ENGINE <4M41>

INTAKE AND EXHAUST

INTAKE MANIFOLD

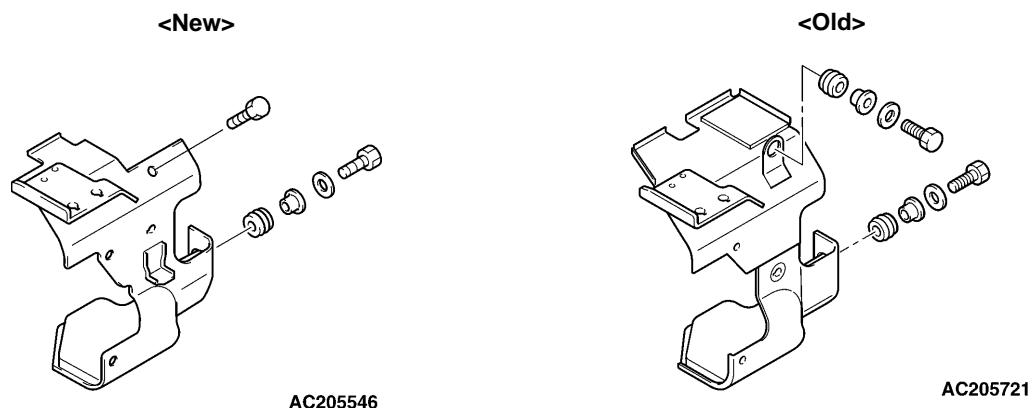
The intake manifold has been changed and an air intake pipe has been added.

EGR SYSTEM

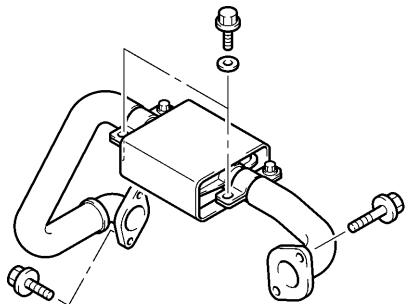
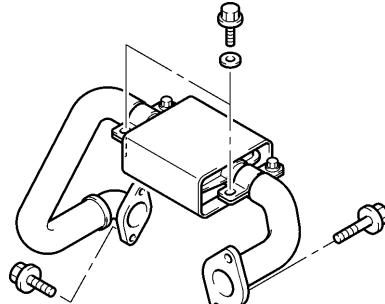
The EGR pipe has been changed.

AUTO-CRUISE CONTROL SYSTEM**AUTO-CRUISE CONTROL SWITCH**

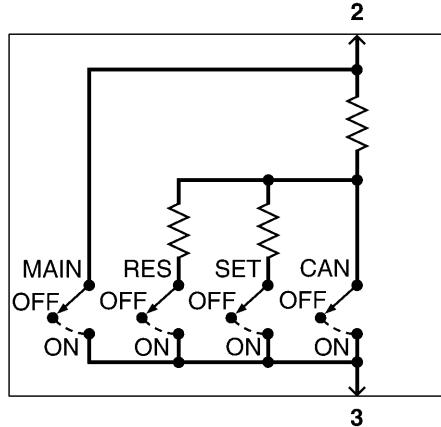
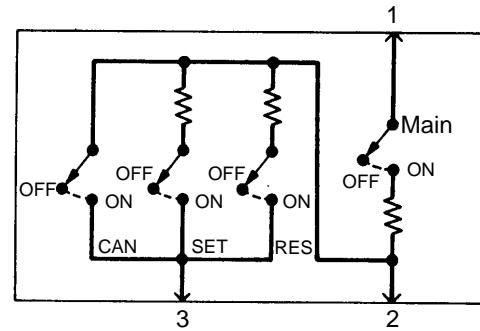
The auto-cruise control switch for the vehicles with 4M41 engine has been changed.
